CHARTER TOWNSHIP OF MERIDIAN
PLANNING COMMISSION
AGENDA

DECEMBER 21, 2015

**Special Use Permit #15171
(Chick-fil-A, Inc.)
December 21, 2015**

RE: Special Use Permit #15171 (Chick-fil-A, Inc.), construct a fast-food restaurant with a drive-thru facility

FLOODPLAIN MAP

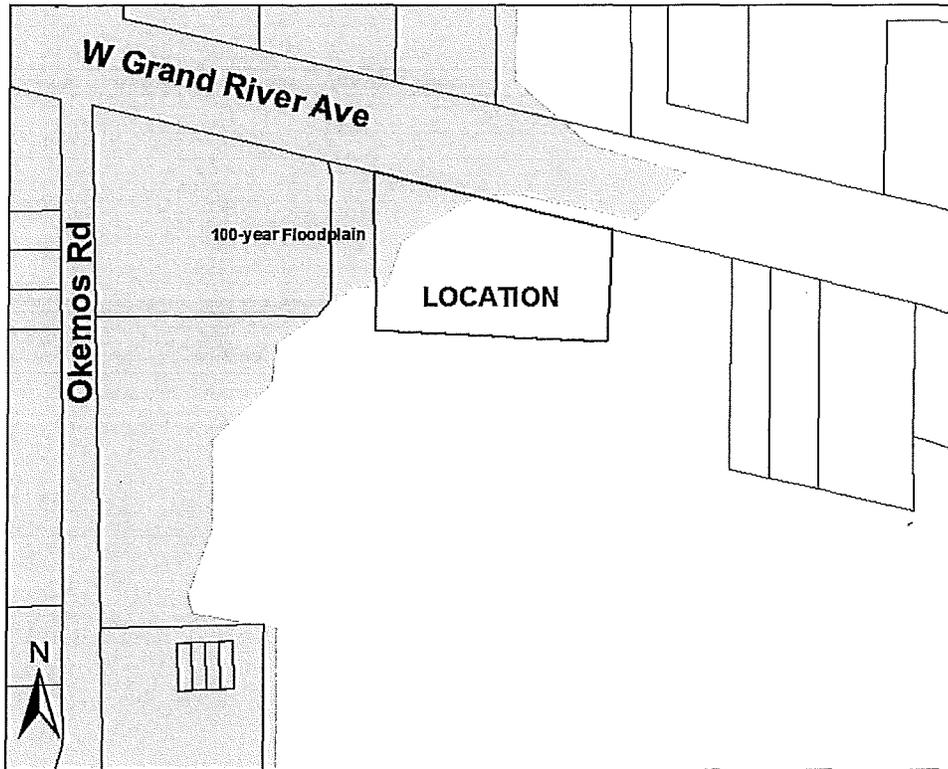
The northwest corner of the site is located in a 100-year Floodplain. The applicant proposes to fill in 73 cubic yards within the floodplain, and to provide a compensating cut of 129 cubic yards. The cut/fill ratio is 1.77 to 1. The minimum required by ordinance is a 1:1 cut/fill ratio. The 100-year floodplain is present on the site, indicated by the shading in the map above at an elevation of 842.1 feet above sea level.
